The Secretary NSW Department of Planning, Industry and Environment

Submission in Relation to State Significant Development Application – 10384 – 2-60 Cumberland Street, The Rocks – Sirius Site

Picture 1 – View to Sirius Building from Mercantile Hotel Rooftop

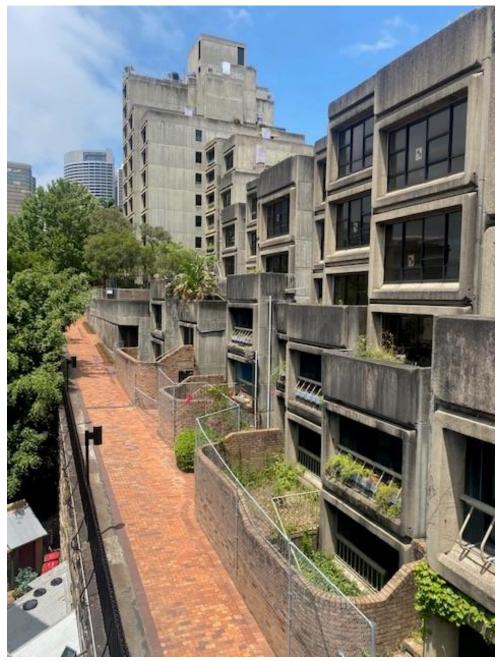
We have reviewed the submitted Noise Impact Assessment prepared by Acoustic Logic and do not consider the assessment has made assumptions for noise related to the approved SSD 8665 for the use of the rooftop for a bar and restaurant both indoors and outdoors. We therefore recommend that the Noise Assessment is updated to consider the future development at the Mercantile Hotel and recommend appropriate mitigation measures. Alternatively, should the proposal be approved then at a minimum the DPIE should impose a condition of consent that requires all bedrooms and living rooms within 100m of the Mercantile Hotel to be provided with windows with acoustic seals, and 13.52mm lam/ 24mm airgap, 13.52mm lam glazing. Such levels of glazing are consistent with the proposed levels of glazing at the interface of the Bradfield Highway where significant noise levels will be experienced.

We would also request that external wall construction within 100m of the Mercantile Hotel is consistent with those recommended within the Nosie Assessment Report for facades in line with or above the Bradfield Highway.

The following images were taken from the rooftop of the Mercantile Hotel which is the subject of SSD 8665. The photos demonstrate the close interface between the Hotel and the Sirius Building which further demonstrates the need for appropriate acoustic mitigation measures to windows and walls of the Sirius building to ensure appropriate amenity for future residents and minimise opportunity for complaints against the Mercantile Hotel use.
